Subject: **San Onofre Nuclear Generating Station Units 2 and 3
Docket Nos. 50-361 and 50-362
Amendment Application Numbers 215 and 200
Proposed Change Number (PCN) 536
Request to Revise Technical Specifications to Create
and Implement the Fuel Storage Program**

SPENT FUEL POOL STORAGE WITH NO BORAFLEX
AND
CREDIT FOR SOLUBLE BORON
SAN ONOFRE NUCLEAR GENERATING STATION, UNITS 2 AND 3

FIGURE 3.7.18-1

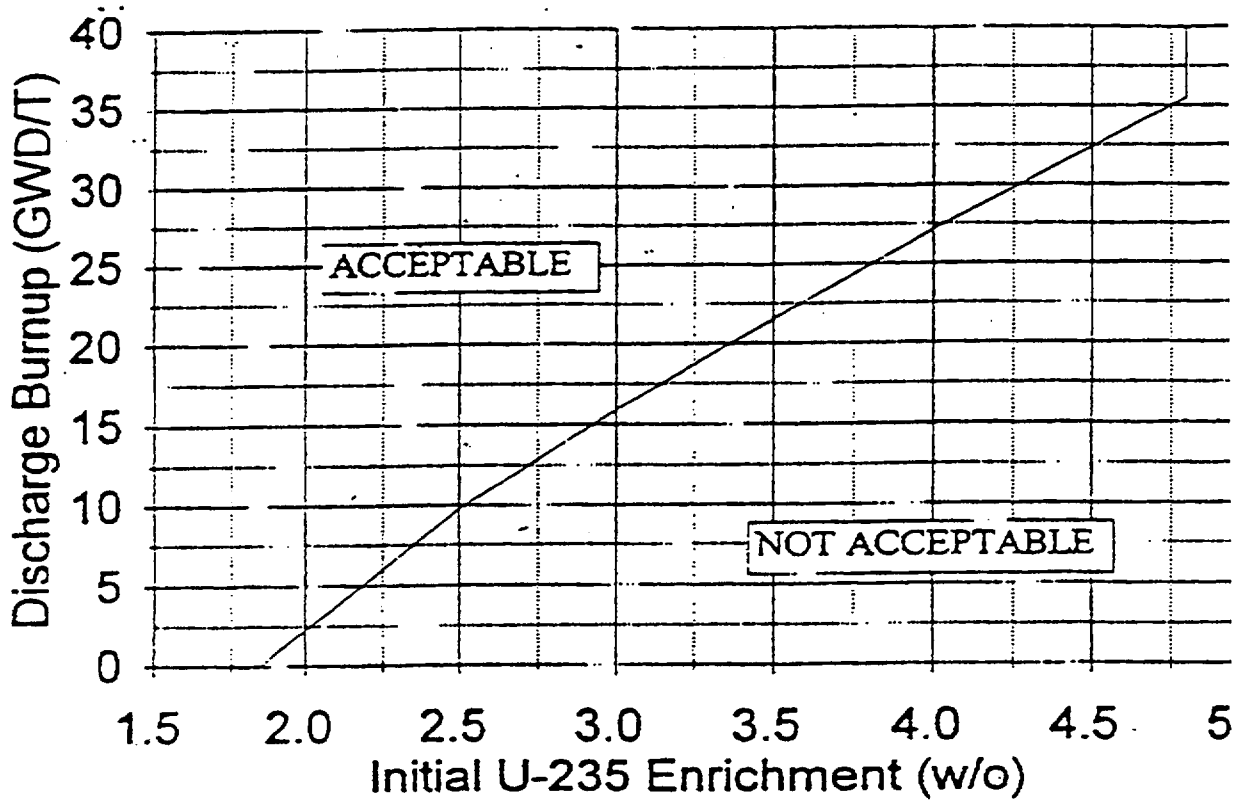
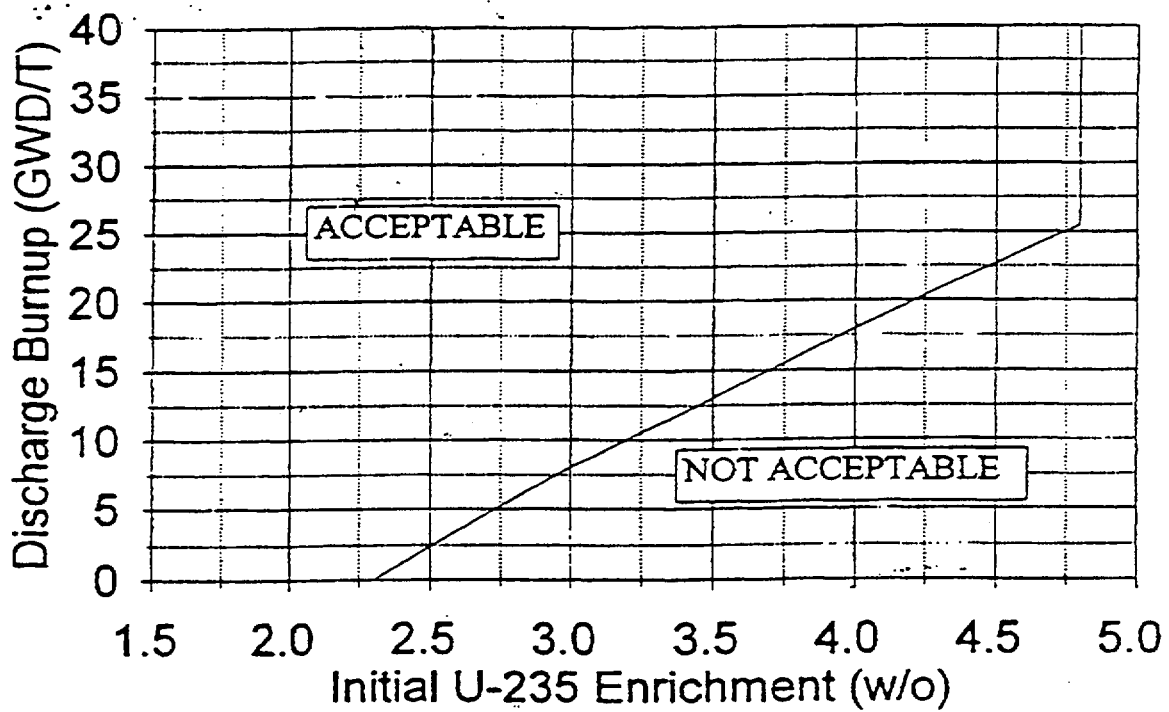
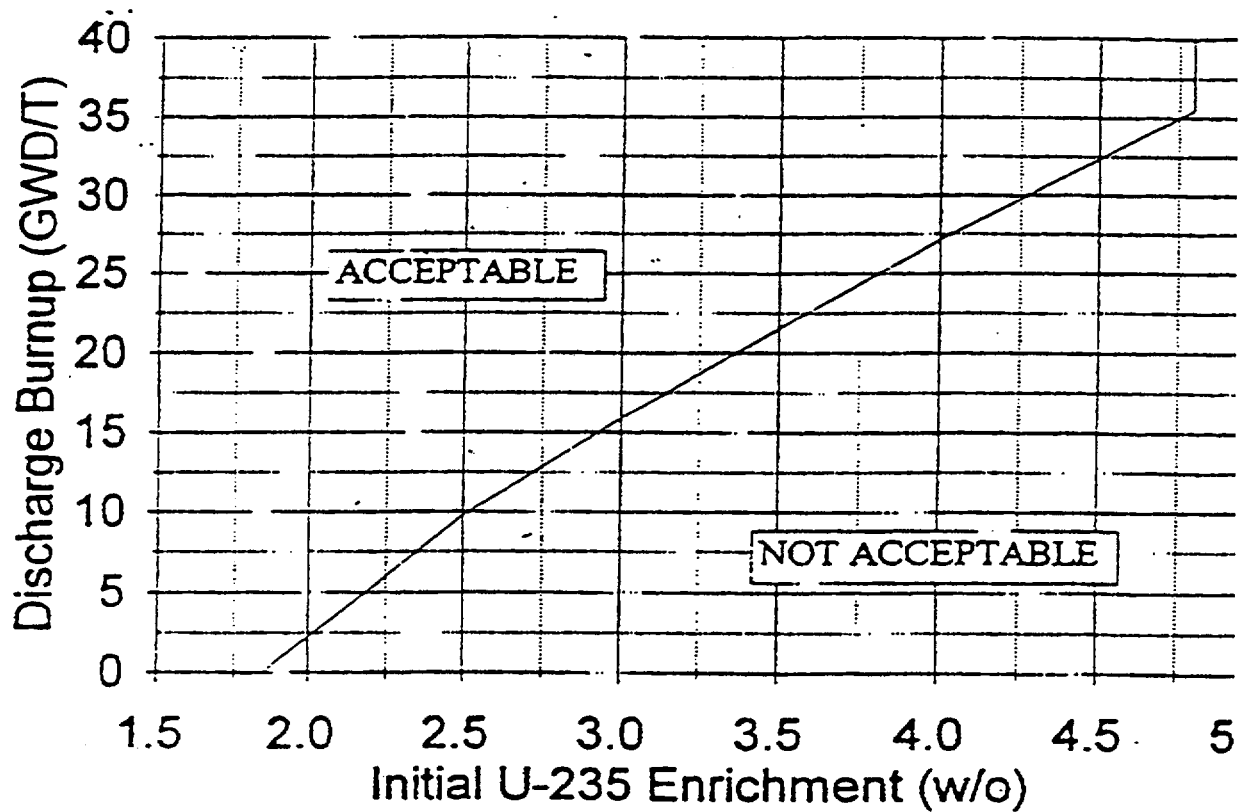
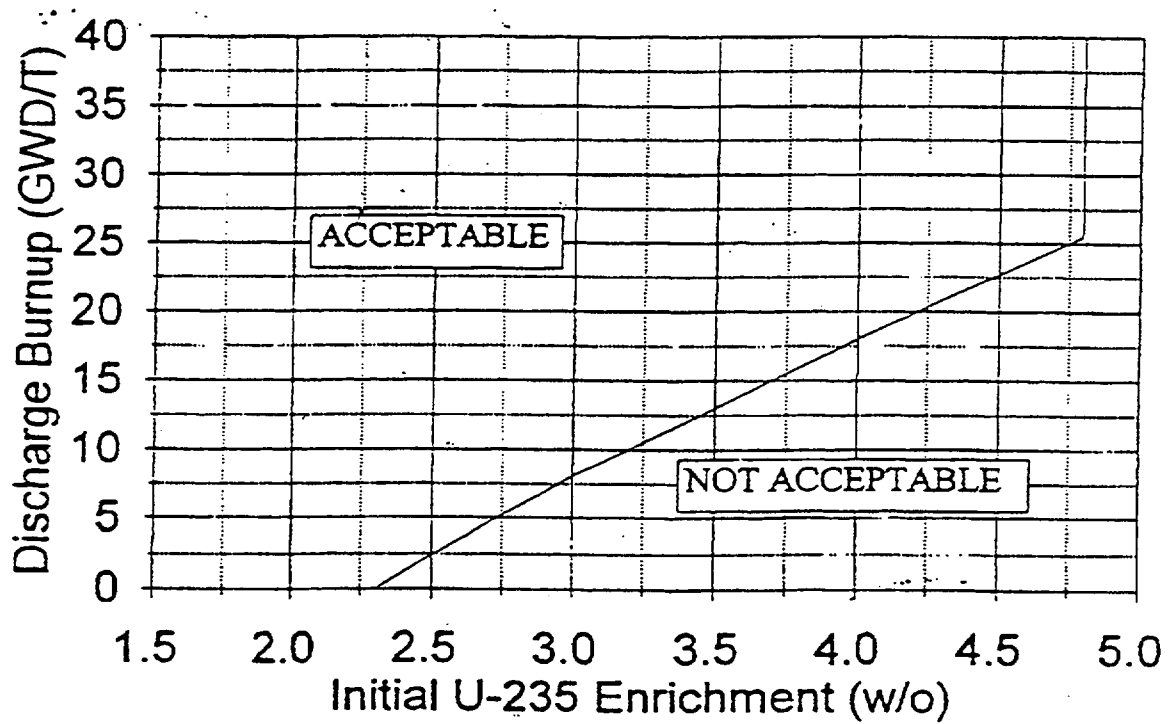
LCO 3.7.18 is completely revised, and Figures 3.7.18-1 and 3.7.18-2 are deleted. Specific storage requirements for SONGS Units 1, 2, and 3 fuel assemblies stored in Units 2 and 3 Spent Fuel Pools (SFP) are deleted and replaced with reference to Technical Specification Section 5.5.2.16, "Fuel Storage Program."

The replacement of Figures 3.7.18-1 and 3.7.18-2 with Section 5.5.2.16 is an administrative change, not a technical change. This change maintains NRC control as Section 5.5.2.16, "Fuel Storage Program," is part of the Technical Specifications, and the Fuel Storage Program will be uniquely identified in Section 5.5.2.16 such that updates to the Fuel Storage Program will require NRC approval.

FIGURE DELETED

FIGURE DELETED
